MEMORANDUM

From:	Catherine Brimble Senior Landscape Officer		
Service	SDL Landscape and Trees	App No:	252379
Address:	Parcel N, Arborfield Green, Berkshire.		
Proposal:	Application for approval of Reserved Matters pursuant to Outline Planning Consent O/2014/2280 for the erection of 67 dwellings with associated infrastructure, access and landscaping. Details of appearance, landscaping, layout and scale to be considered.		
Type of Development:	Major Dwellings (10+)		
Site Visit Made:	Yes/No

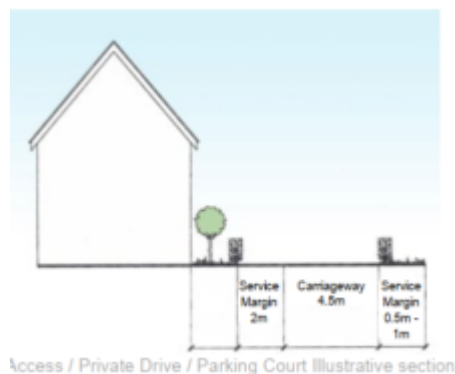
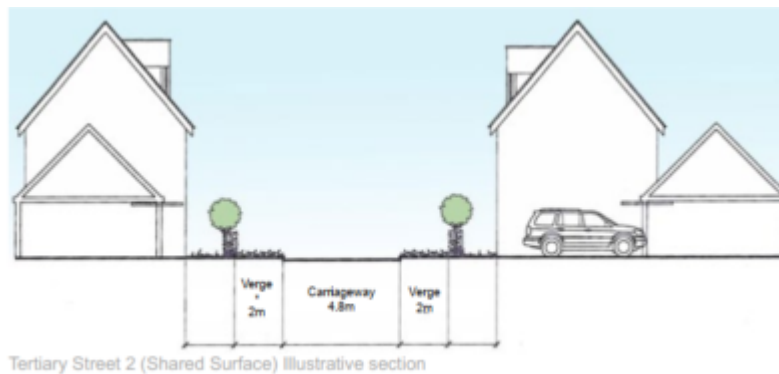
1. The Village Edge character area in the Design Code (DC) relates to the edge of the development fronting onto the Linear Park to the south of the site. The building form and typologies are detailed for each character area on page 18 of the DC and indicates that this street should be lower density and have a balance between hard and soft landscape treatment and incorporate tree planting. Front gardens should also reinforce the soft landscape street character. This does not appear to be referenced in the Design Compliance Statement.
2. Within the movement framework of the DC the majority of the street typologies within the site are shown as tertiary street type 2. Where there is a shared surface along these streets a 2m service margin is required along dwelling

frontages, however where dwellings are provided on one side of the street a 0.5m-1.0m service margin is required on the opposite side of the road (my emphasis). This is highlighted in the two extracts below from page 23 of the DC.

The compliance document shows a different interpretation indicating a service margin on both sides of the street fronted by dwellings as being a minimal 0.5m as shown below. This is not acceptable and has a significant impact on layout which will be discussed further.
